Title of Change:	Rectifiers in TO277 package changes case outline from SMPC4.6 to SMPC4.6U
Proposed First Ship date:	15 Sep 2021 or earlier if approved by customer
Contact Information:	Contact your local ON Semiconductor Sales Office or Phuong.Hoang@onsemi.com
PCN Samples Contact:	Contact your local ON Semiconductor Sales Office or < PCN.samples@onsemi.com >. Sample requests are to be submitted no later than 30 days from the date of first notification, Initial PCN or Final PCN, for this change. Samples delivery timing will be subject to request date, sample quantity and special customer packing/label requirements.
Additional Reliability Data:	Contact your local ON Semiconductor Sales Office or songyong.sim@onsemi.com
Type of Notification:	This is a Final Product/Process Change Notification (FPCN) sent to customers. FPCNs are issued 90 days prior to implementation of the change. ON Semiconductor will consider this change accepted, unless an inquiry is made in writing within 30 days of delivery of this notice. To do so, contact PCN.Support@onsemi.com

文書番号# : FPCN24074XA

発行日: 08 Jun 2021

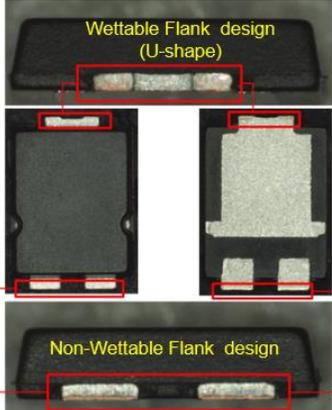
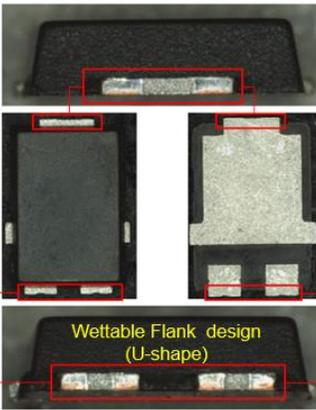
この最終製品変更通知 (FPCN) は、TO-277 にパッケージされたデバイスのケース外形図 SMPC4.6U を認定する計画を発表するものです。この変更の目的は、前面ピンのはんだ付け性を向上させることです。

SMPC4.6	SMPC4.6u	Remarks
 <p>Wettable Flank design (U-shape)</p> <p>Non-Wettable Flank design</p>	 <p>Wettable Flank design (U-shape)</p>	<ul style="list-style-type: none"> Better AOI for wettable flank design SMPC4.6 wettable flank for heat sink only SMPC4.6u wettable flank for both heat sink and pins
		<ul style="list-style-type: none"> Exposed tie bar design

名称	変更前の表記	変更後の表記
クリップ	Copper C19210, dimple design	Copper C19210, flat design
モールド・コンパウンド	E'dale ELER-8-500C	Sumitomo G700LA
ケース外形	SMPC4.6	SMPC4.6U
ケース外形仕様	340BQ	340BQ
